CONTRACTOR SUBMITTAL TRANSMITTAL FORM REV. A

PROJECT: HILO WWTP REHABILITATION
AND REPLACEMENT PROJECT - PHASE 1

Reference: Section 11395E: Blend Tanks Odor Control System and Section 11395F: Solids Odor Control System for Hilo WWTP Rehab and Replacement Project, Phase 1
Customer Order#: 24077-00049
IMS Project# 40243

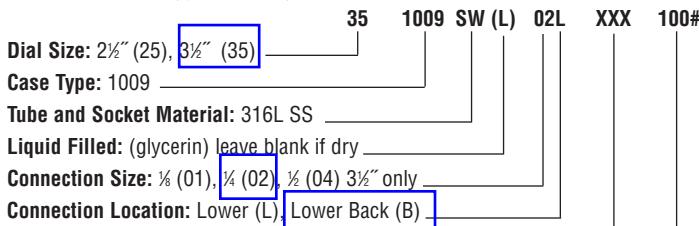
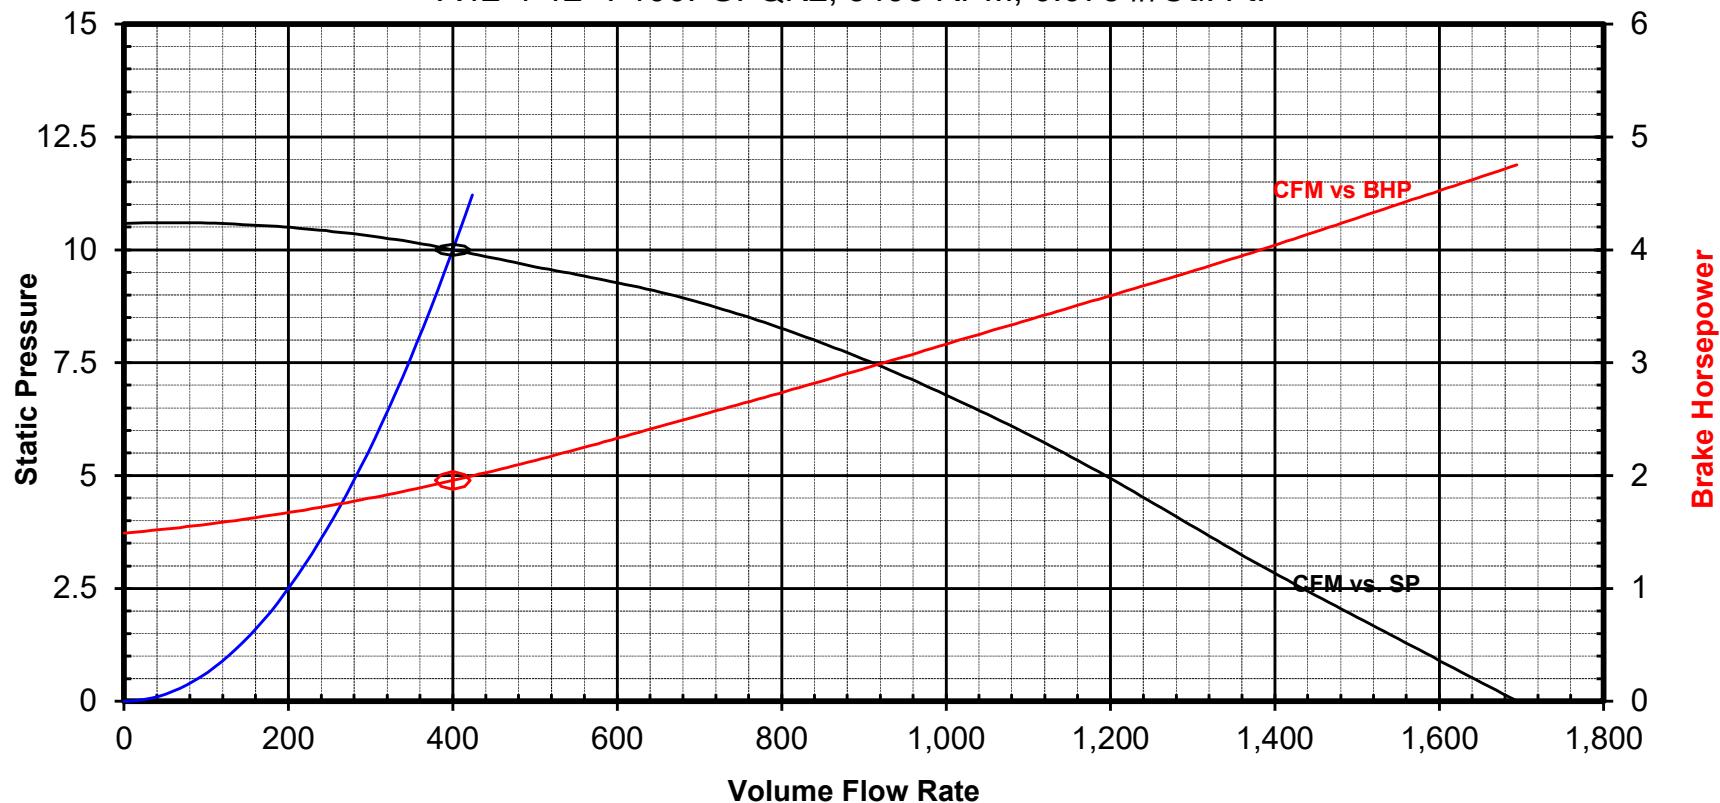
1. Provide pressure gages with 3 1/2" size instead of the submitted 2.5" size.

- 1) NAN Inc. – Provide pressure gages with 3 ½" size instead of the submitted 2.5" size

IMS – Noted, we will provide 3.5" sized pressure gauges for the system. Cutsheet included in this letter.

DATA SHEET

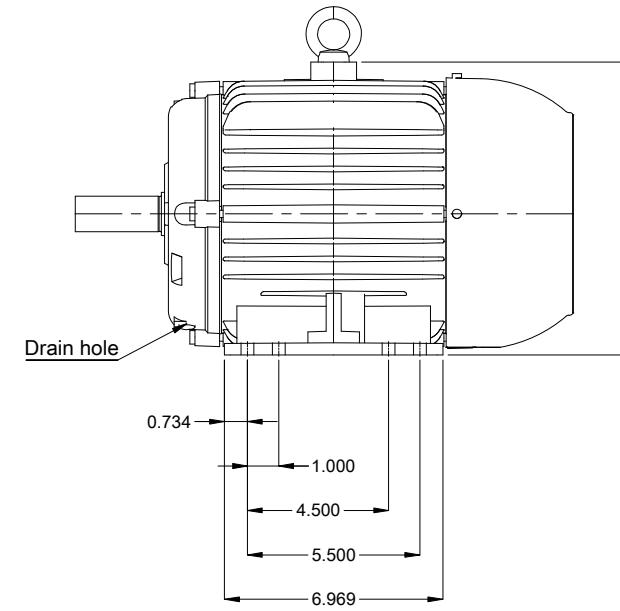
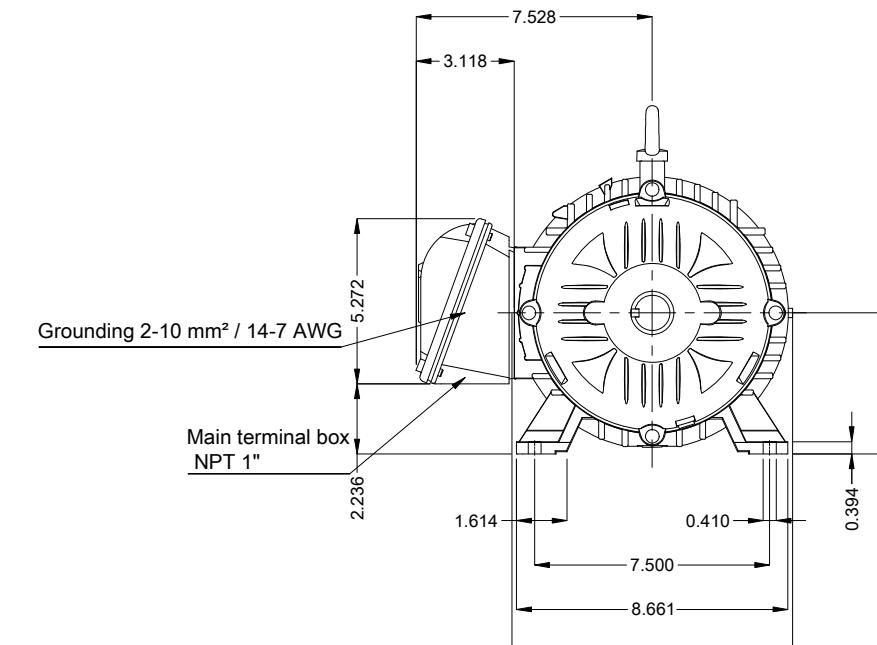
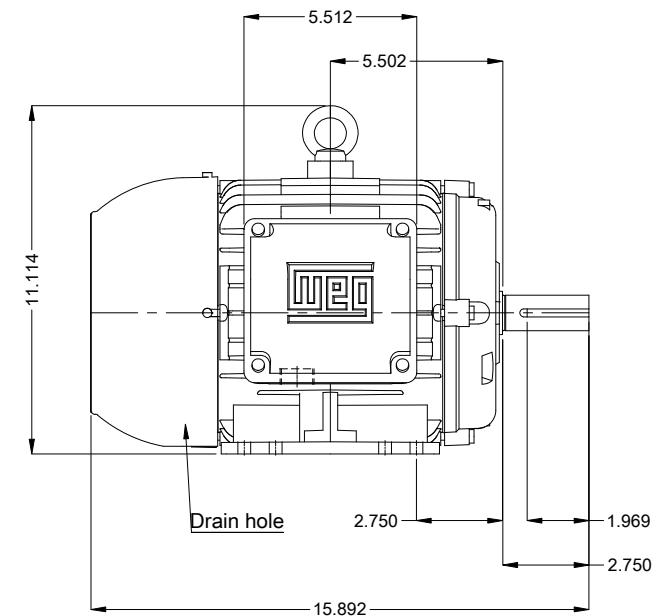
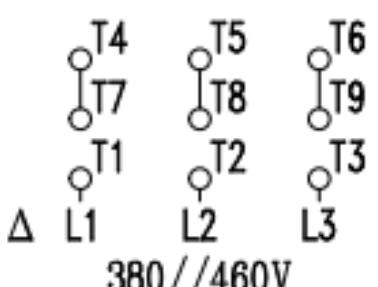
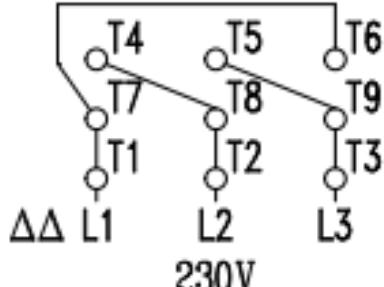
2. Fan selection for the I-BOX 5000 is too close at the tip of the curve at 7" w.c. and shutoff head at 7.5". Select the fan with a minimum of 2-3" between the design pressure and shutoff pressure. This is to account for any future pressure drop as the media gets exhausted.

- 2) NAN Inc. – Fan selection for the I-BOX 5000 is too close at the tip of the curve at 7" w.c. and shutoff head at 7.5". Select the fan with a minimum of 2-3" between the design pressure and shutoff pressure. This is to account for any future pressure drops as the media get exhausted.

IMS – Noted, we will provide the fan with a 3 HP motor to accommodate the predicted static pressure. New fan curve and motor data sheet included in this letter.

E	HILO WWTP BIOLOGICAL ODOR CONTROL SYSTEM OPTION B GENERAL LAYOUT DRAWING			
NT	NAN, INC. HILO, HI			
	13135 DANIELSON ST., SUITE 204 SAN DIEGO, CA 92064, USA TEL: 858-486-1620			
PROJECT 40243	CODE	DRAWING 40243_L1	SHEET 1 OF 2	REV B

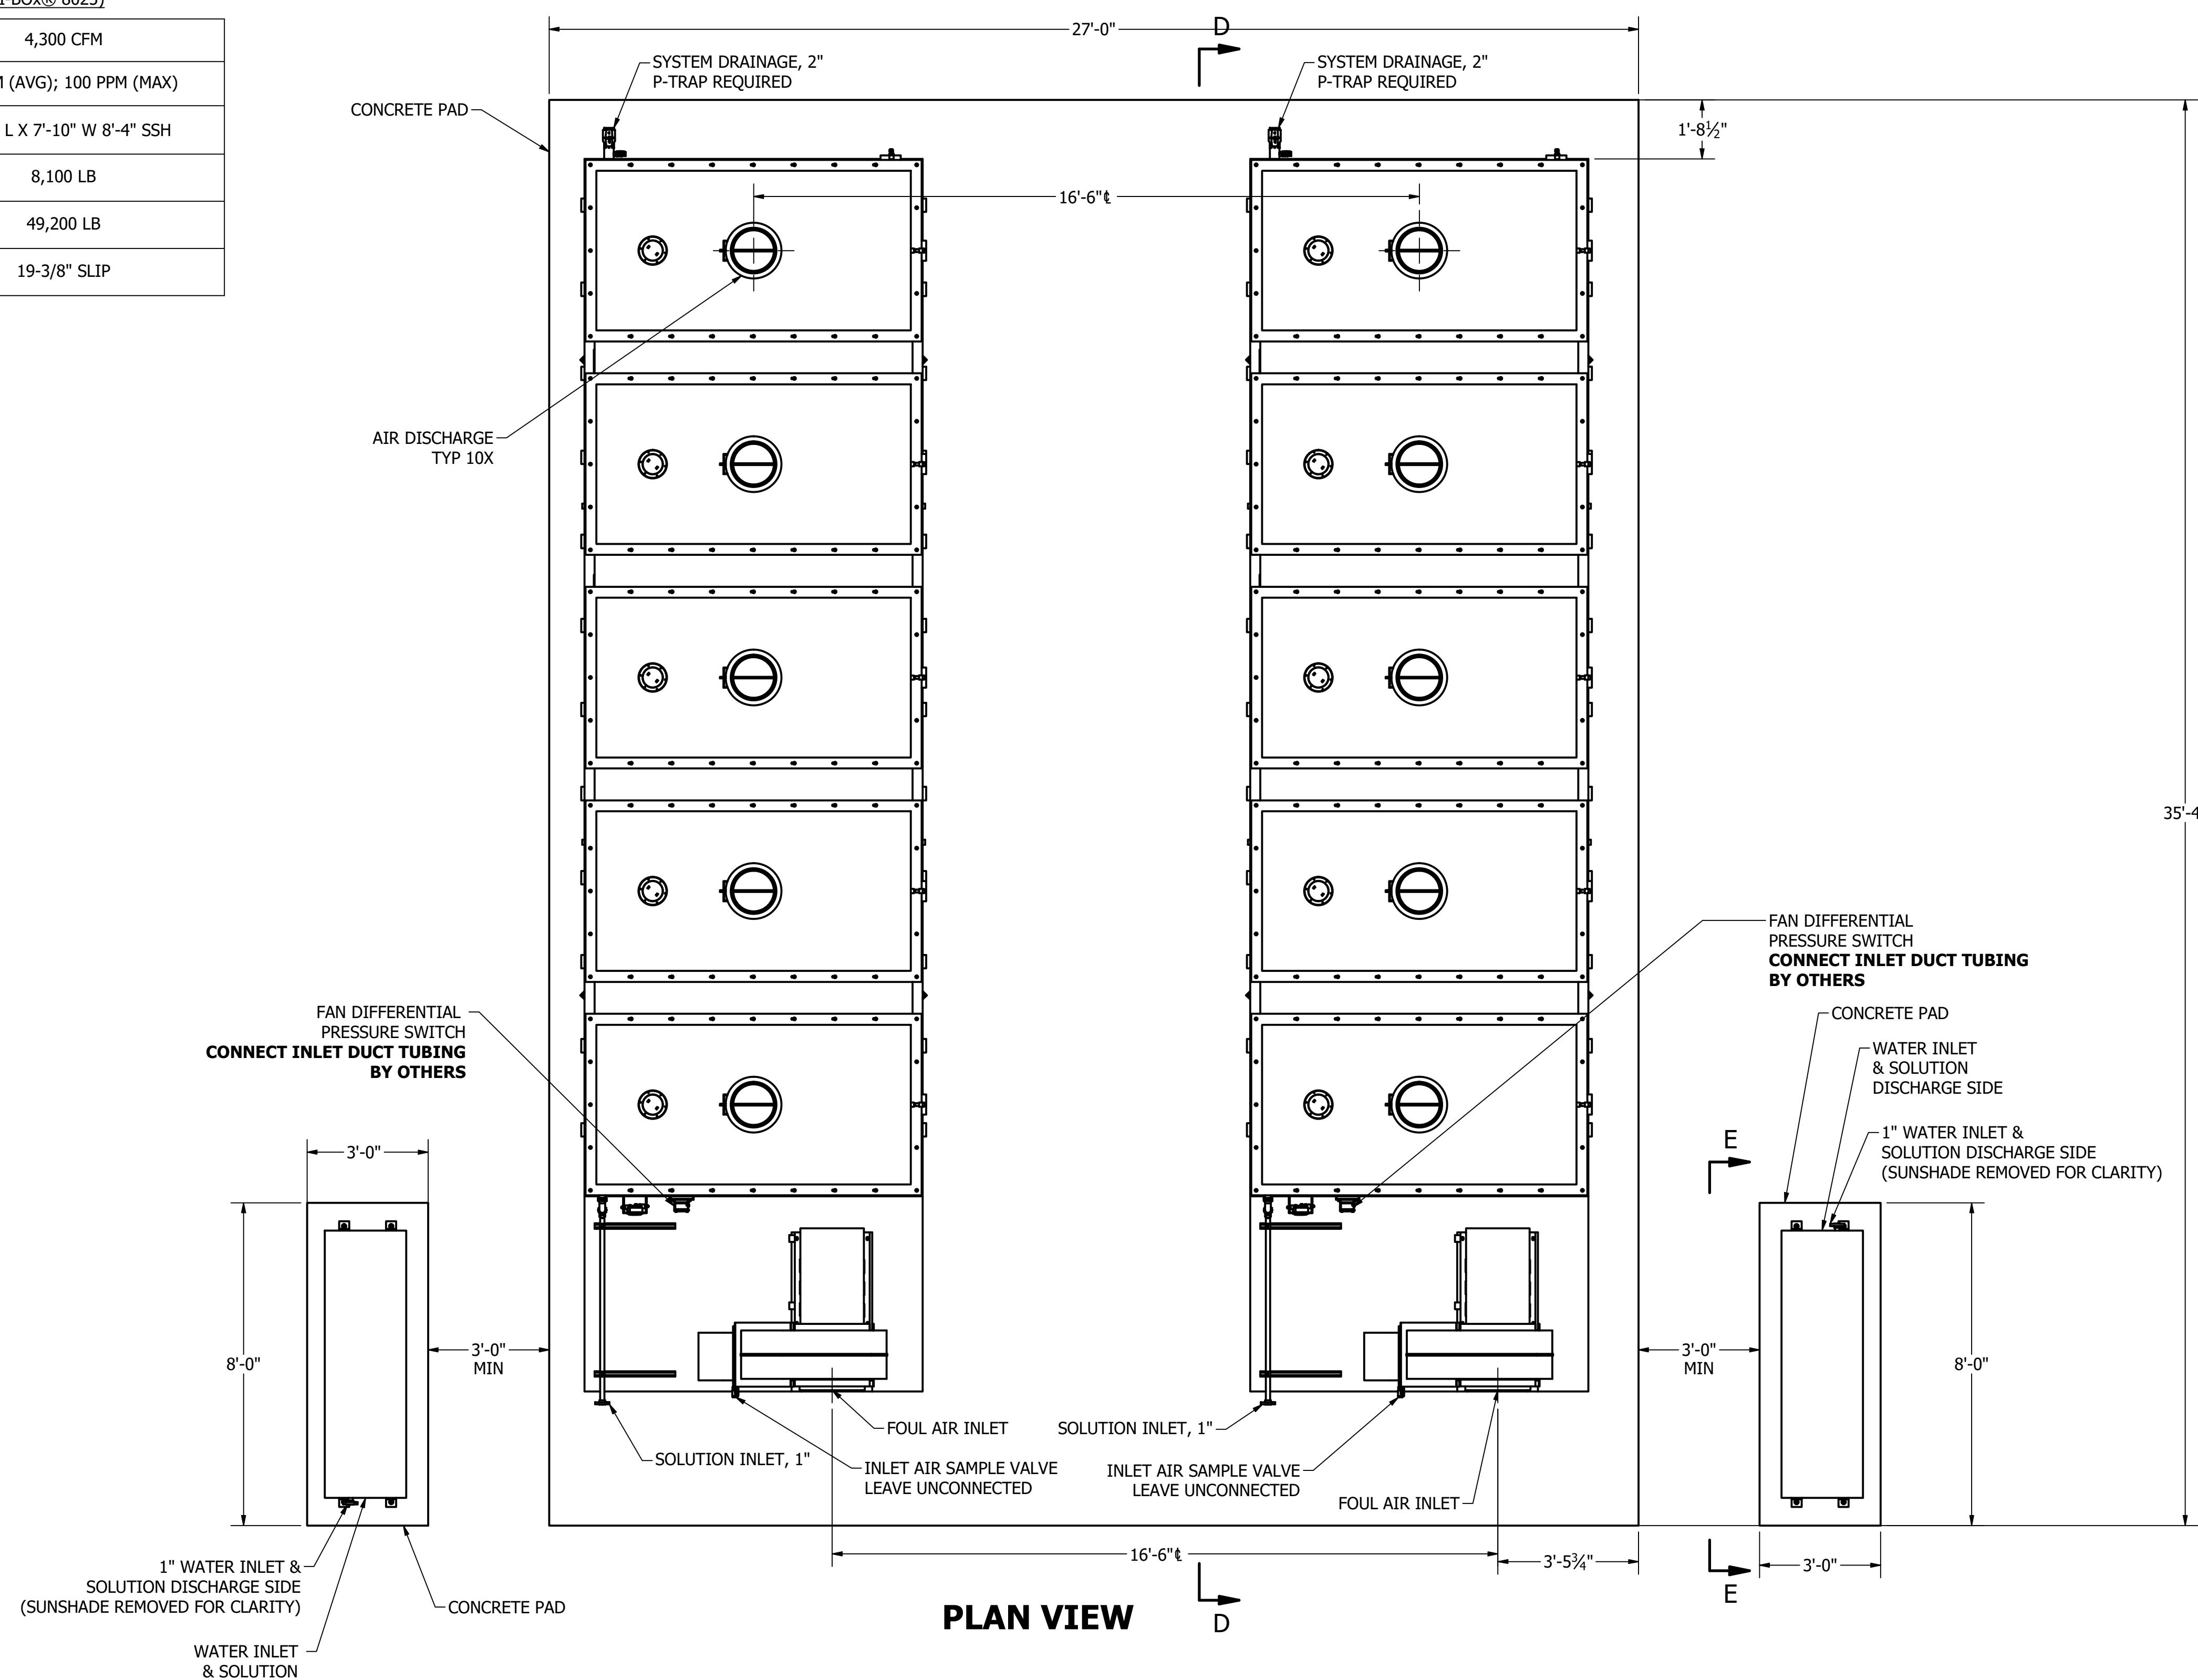
3. The option with five individual no-loss exhaust stacks, each equipped with a volume control damper, is acceptable in lieu of the one single combined header as shown currently on the drawings. Provide a sample line with isolation valve for each stack.

- 3) NAN Inc. – The option with five individual no-loss exhaust stacks, each equipped with a volume control damper, is acceptable in lieu of the one single combined header as shown currently on the drawings. Provide a sample line with isolation valve for each stack.

IMS – Noted, we will proceed with the individual exhaust stack option and include the sample lines with isolation valves. Layout drawing included in this letter.
